City of Biddeford
Planning Board
June 07, 2023 6:00 PM City Hall
Council Chambers, & Zoom
<https://biddeford.zoom.us/j/98200601229?pwd=MXpvUFdjNXdkL3NienI4UWIDVVZKZz09>
Webinar ID 982 0060 1229; Passcode 556617

PLANNING BOARD STAFF REPORT

RE: **2023.31 Site Plan Application for Diversacorp Holdings LLC to construct four (4) residential condominium units. Property is located at 20 Clifford Street (Tax Map 39, Lots 301-1 & 304) in the Residential-2 zone.**

RE: **2022.11 Site Plan and Subdivision Amendment Review for Tom Watson & Co. at 10, 20, 26 and 30 Upper Falls Way (formerly Gooch Street) (Tax Map 40, Lots 55, 55-3, and 56-1) in the MSRD-3 zone and GD-1 Shoreland Overlay zone.**

SKETCH PLAN
4-UNIT CONDOMINIUM
20 CLIFFORD STREET
BIDDEFORD, MAINE

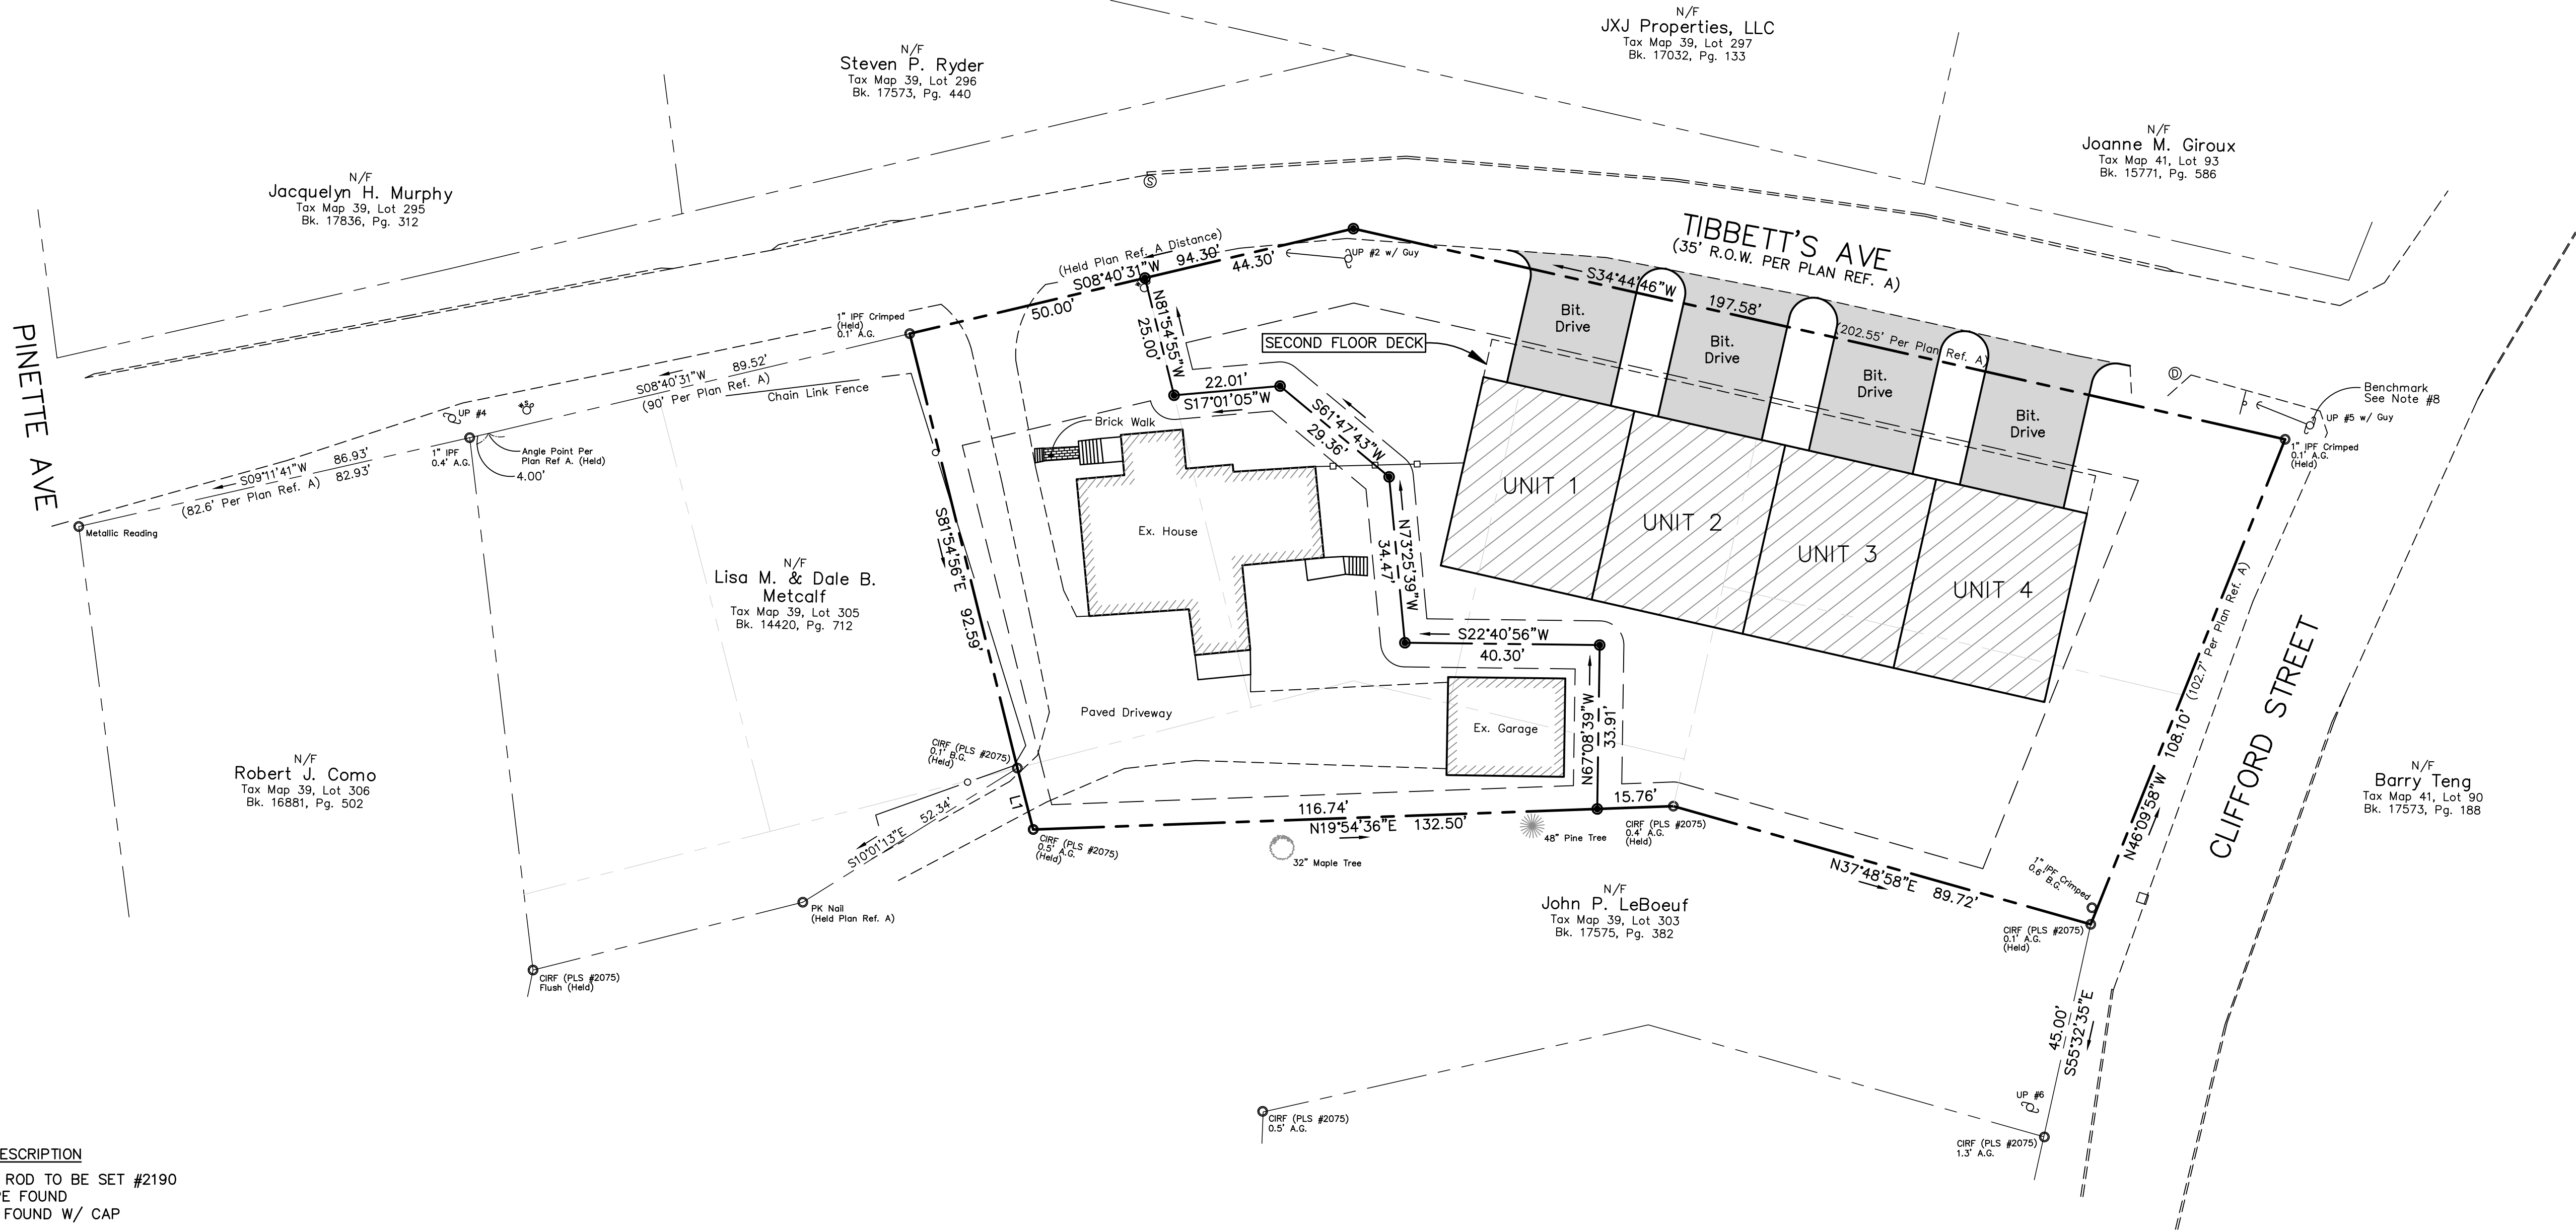
- The property slopes down toward both Clifford Street & Tibbett's and appears to be fairly steep, so questions regarding stormwater and runoff is a concern. The developed properties on the west side of Tibbett's are below the project site as the slope continues in that direction.

- Very tight site especially with the existing grades and not, at this point, knowing what their plans are for grading.
- Sight lines for driveway / roadway safety. Emergency vehicle access.

- Only garage and driveway parking (4 stalls max per lot) and due to the width of Tibbett's Ave. No on street parking on Tibbett's.
- Tree Removal. Since the site is fully vegetated, The applicant should clarify how many trees on the parcel will be removed. And how that may impact erosion.

- Future plans should include topography and stormwater / sewer connections
- Site is within the MS4 urbanized area.

1. The condos are proposed to access Tibbett's Ave utilizing 4 separate driveways, one serving each unit.
2. Tibbett's Avenue is only a 35' wide ROW and the access points are located in close proximity to the Clifford / Tibbett's intersection.
3. The property slopes down toward both Clifford Street & Tibbett's and appears to be fairly steep, so questions regarding stormwater, site runoff (ice on roadways etc.) is a concern. The developed properties on the west side of Tibbett's are below the project site as the slope continues in that direction.
4. Very tight site especially with the existing grades and not, at this point, knowing what their plans are for grading (homes & driveways).

5. Tibbett's seems to have sewer line running down it but the plans don't show waterlines.
6. Trash removal / storage. I am assuming that they will be proposing garbage cans in garages with curbside pick-up, but...
7. Traffic - Sight lines for driveway / roadway safety. Emergency access??? Hydrant locations?
8. Only garage and driveway parking (4 stalls max per lot) and due to the width of Tibbett's Ave. no on street parking.
9. Homeowner's Association / property maintenance (could be a challenge due to the small size of the lot)

Plunge Pool Design – Civil Plan Set 5-16-23 – Drawing No. C-30

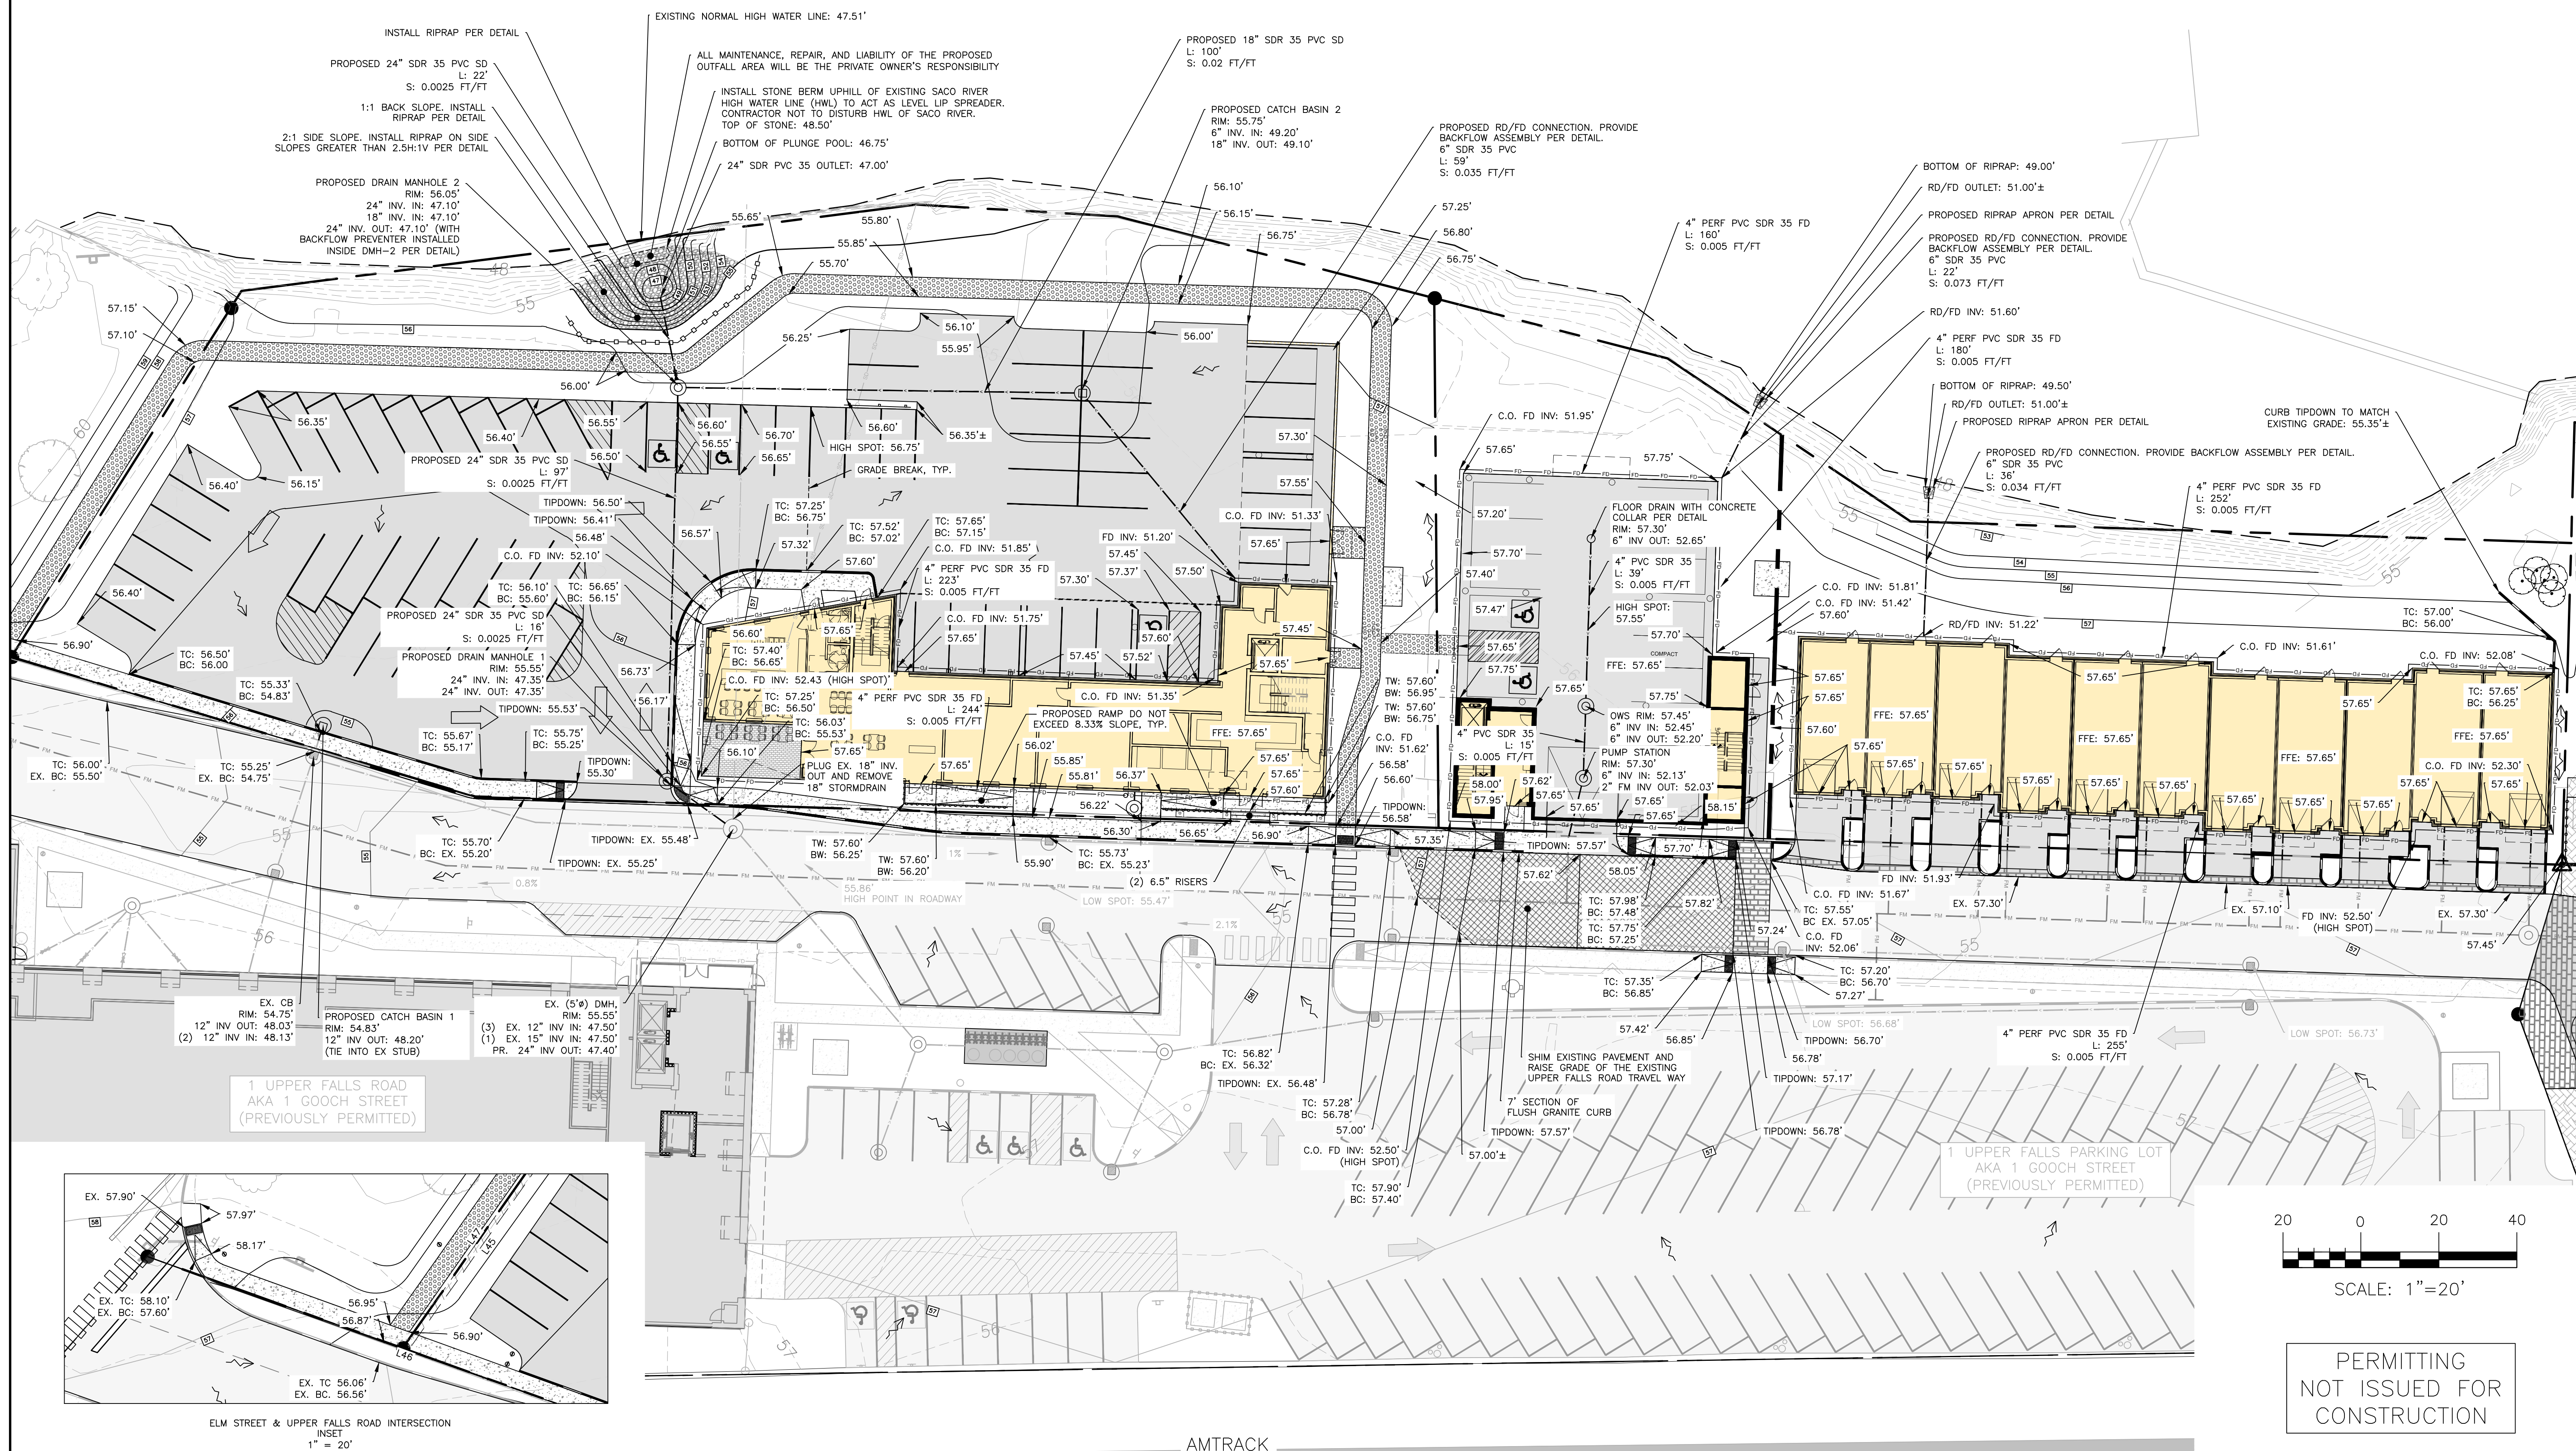
The plunge pool is designed as stormwater discharge point which will have 21" of standing water, during non-storm events, but will collect the discharge and slow release the discharge into the Saco River. In simple terms, the plunge pool is designed similar to a bathtub as it temporally holds the stormwater, during storm events and slowly discharges as the plunge pool begins to fill. As proposed, the top plunge pool elevation begins at a 55 foot (55') elevation above the normal high water mark and down to a 47 foot elevation (8 foot grade change). The plunge pool is designed with rip-wrap for erosion control / containment. The plunge pool will also include a four foot (4') tall, above grade, fence adjacent to the River Walk and additional landscaping / plantings are also being proposed around the plunge pool for screening and additional safety at the top of the plunge pool.

Staff is comfortable moving forward with the Board's approval of the amended Site Plan and Subdivision application, with the understanding that the remaining engineering issues will be resolved to the satisfaction of the Public Works Director and Engineering Director prior to a the construction of the proposed plunge pool, safety fencing and proposed landscaping.
